Test Bench

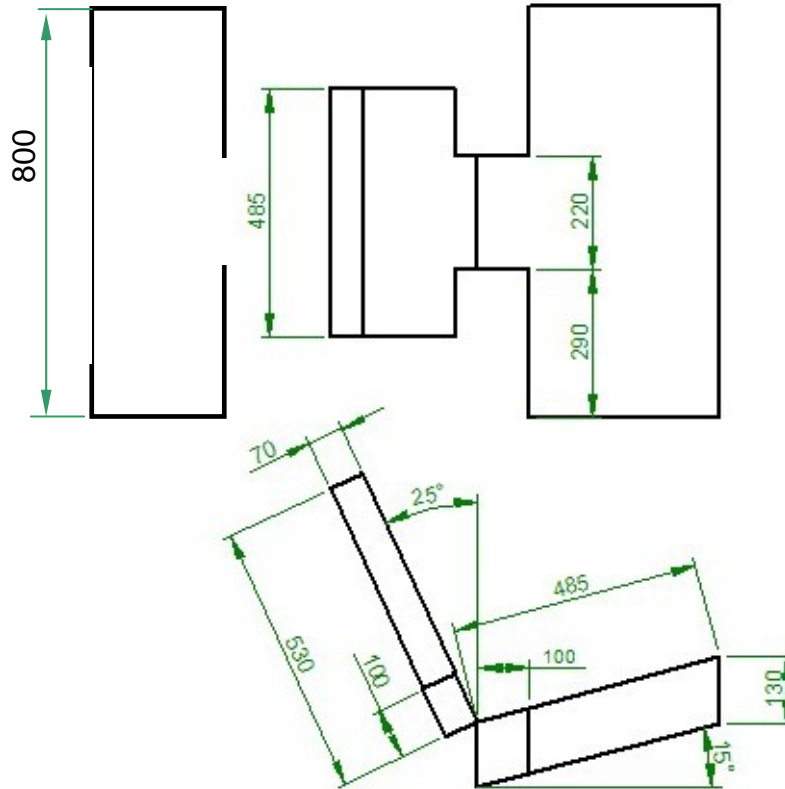
Dimensions	Action
From car data	Acceptable OR new data is available?

Seat cushion foam (from car data) and covering:	Actions
The characteristics of the seat cushions are defined as FTSS cushion specification – T75500.	needs better specification – FTSS? OR new data is available?
The foam covering - sun shade cloth made of poly-acrylate fibre.	needs better specification - FTSS? OR new data is available?

Head restraint representation	Action
Is it needed or are CRF/VRF enough?	Data needed - CRS/Vehicle manufacturers

ISOFix anchorages	Action
Location for alternative 3 rd point	Data needed - Vehicle manufacturers

Adult Belt	Action
Is it needed for restraining older children OR will the restraint be an integral 3 or 5 point belt within the CRS? (Will the test bench need belt anchorage locations?)	Apply reg 14 Clarification? Put the centre axis of the ISOFix to the centre axis of the adult seating position.

Dash	Action
The current dash may be too stiff if the intension is to measure head and neck loads.	Clarification? No dash. Define energy absorption requirements?
